**KNOXVILLE/KNOX COUNTY METROPOLITAN PLANNING COMMISSION
 SUBDIVISION REPORT - CONCEPT/USE ON REVIEW**

▶ **FILE #:** 3-SB-16-C **AGENDA ITEM #:** 11
 3-A-16-UR **AGENDA DATE:** 4/14/2016

▶ **SUBDIVISION:** HICKORY VILLAGE
 ▶ **APPLICANT/DEVELOPER:** GBS ENGINEERING - MARK BIALIK
 OWNER(S): Burton Holdings

Use-on-Review Plans for *Hickory Village*

OVERALL USE-ON-REVIEW SITE PLAN
Scale: 1" = 100'-0"

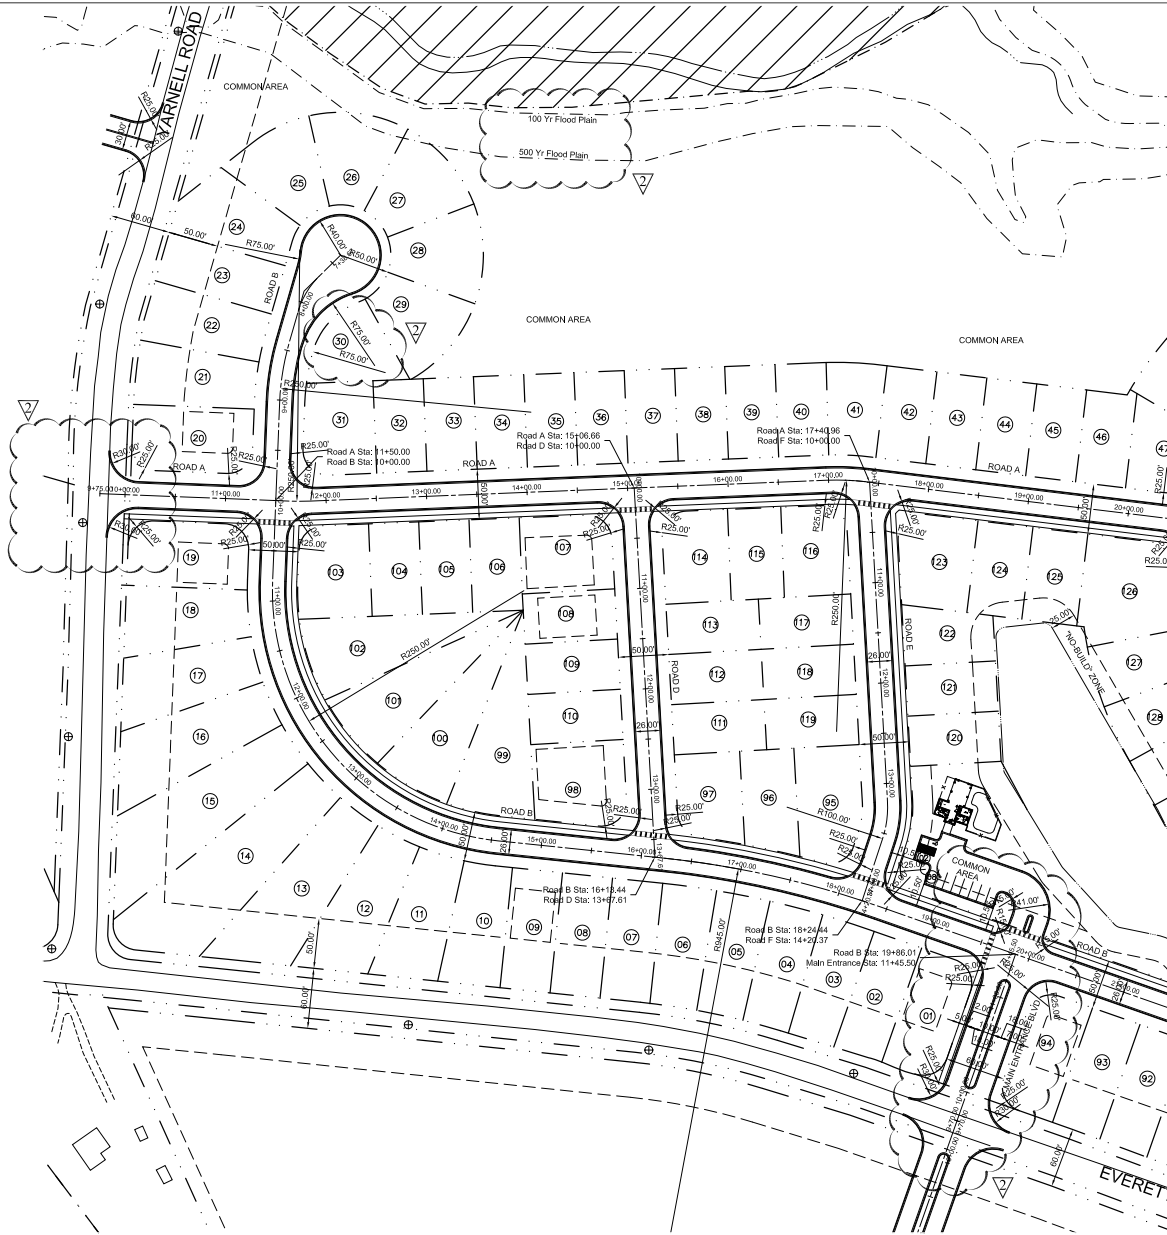
1. Reduction of the horizontal curve radius on Road B at STA 22+34.09 to STA 23+17.96, from 250' to 100'.
2. Reduction of the horizontal curve radius on Road G at STA 14+63.07 to STA 15+58.74, from 250' to 100'.
3. Broken back tangent variance on Road B between STA 31+05.36 and STA 31+55.95, from 150' to 50.59'.
4. Vertical curve variance on Road H at STA 10+75, from K=15 to K=13.33.
5. Vertical curve variance on Road D at STA 12+92.91, from K=25 to K=20.53.

3. Installation of sidewalks as identified on the concept plan with the addition of a sidewalk connection to the clubhouse facility. Sidewalks shall meet all applicable requirements of the Americans with Disabilities Act (ADA) and the Knox County Department of Engineering and Public Works, and shall be installed at the time the street improvements are installed for the subdivision.

8. Meeting all applicable requirements of the Knox County Department of Engineering and Public Works.
 9. Working with the Knox County Greenways Coordinator on establishing the 50' wide greenway easement that is identified on the concept plan.

The proposed subdivision will include sidewalks on one side of the main streets with connections to the amenity area and future connections to the future assisted living facility and the multi-dwelling complex. The "Knoxville-Knox County Park, Recreation and Greenways Plan" identifies a Greenway Corridor along Hickory Creek. Staff is recommending that the applicant work with the Knox County Greenways Coordinator on establishing the 50' wide greenway easement along the north side of Hickory Creek as identified on the concept plan.

TITLE: PARTIAL VIEW OF SINGLE FAMILY GRADING		DRAWN BY: -	SHEET NO:
LOCATION: 1102 EVERETT ROAD KNOX COUNTY, TENNESSEE CLT Map 141, Parcel No. 050		CHECKED BY: -	C4
Owner: BURTON HOLDINGS		FILE NAME: Contours 02/19/16	
		JOB NUMBER 2070	
		ISSUE DATE: 01/22/2016

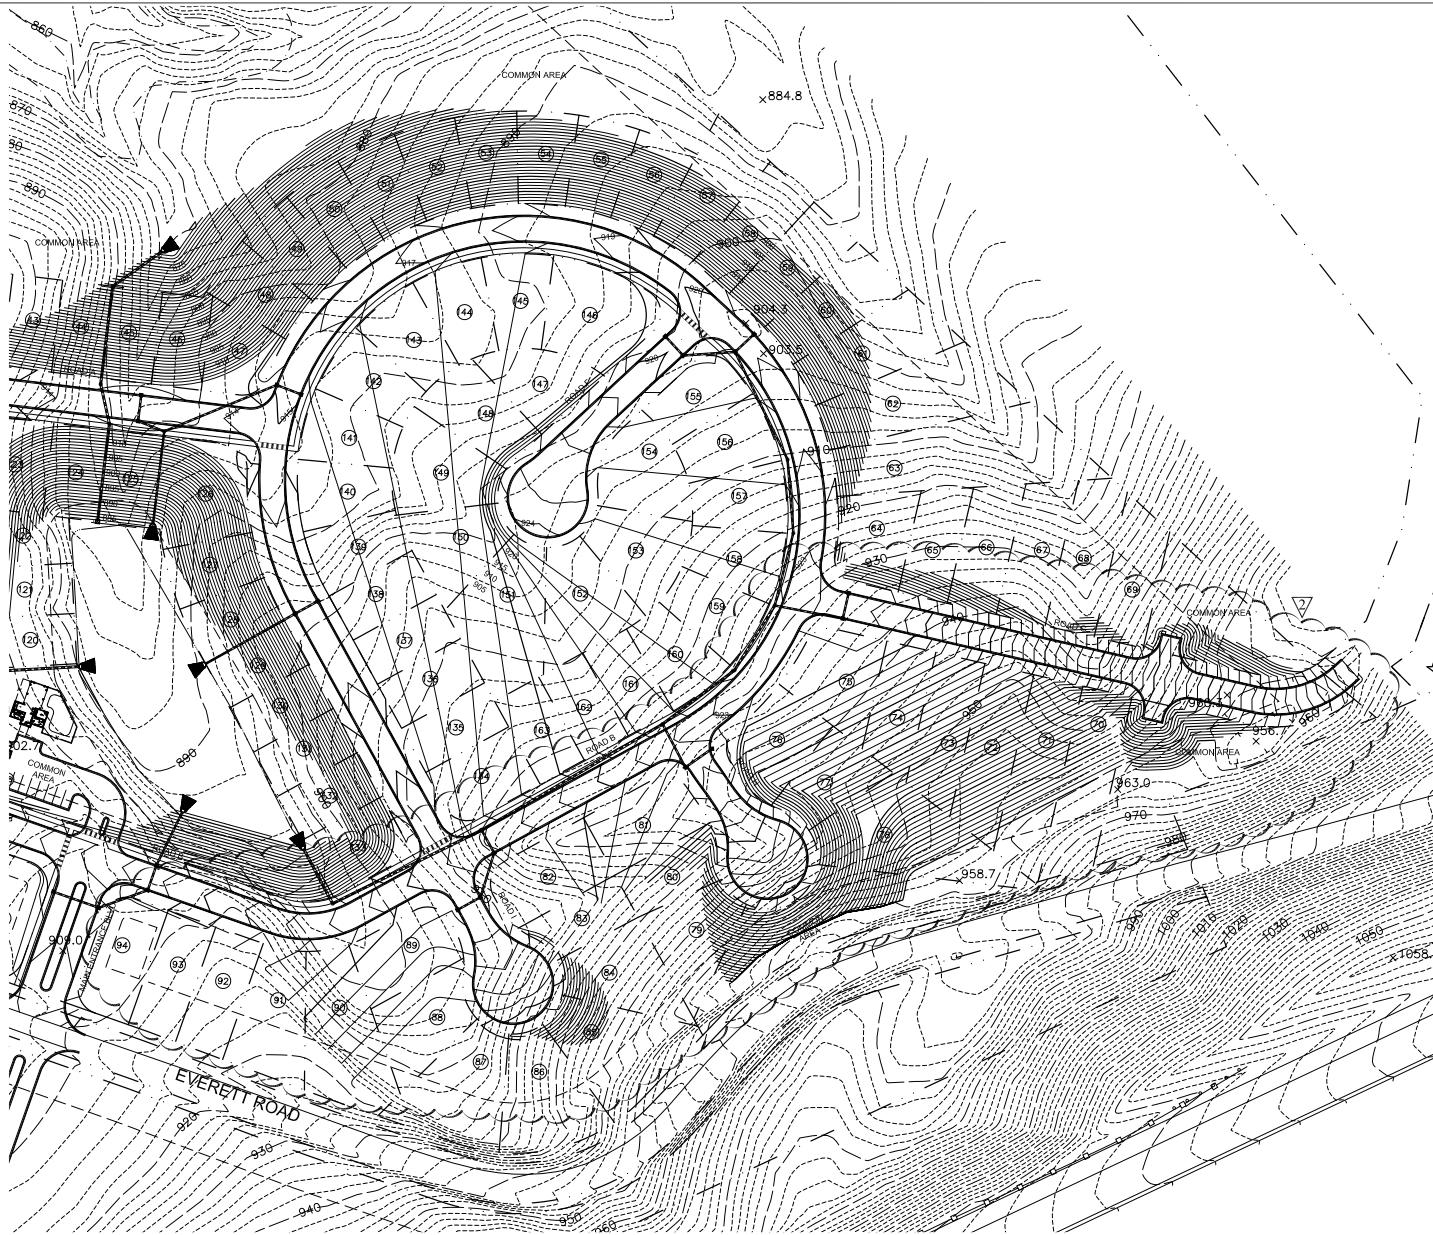
5. Prior to obtaining a design plan approval for the subdivision, submitting a detailed grading plan to the Knox County Department of Engineering and Public Works and Planning Commission Staff that documents all proposed lots will have adequate building sites and yard areas with driveway grades not exceeding a 15% grade. Those lots that cannot comply with this condition will have to be combined with adjoining lots on any final plats submitted to the Planning Commission for approval.

The preliminary site grading plan identified a potential problem with having adequate building sites in the area of Lots 74-89. Staff has recommended a condition that the applicant provide a detailed grading plan prior to design plan approval that documents that adequate building sites are available on all proposed lots.

NOTE:
 • DRIVEWAYS FOR ALL LOTS CANNOT EXCEED 15% SLOPE.
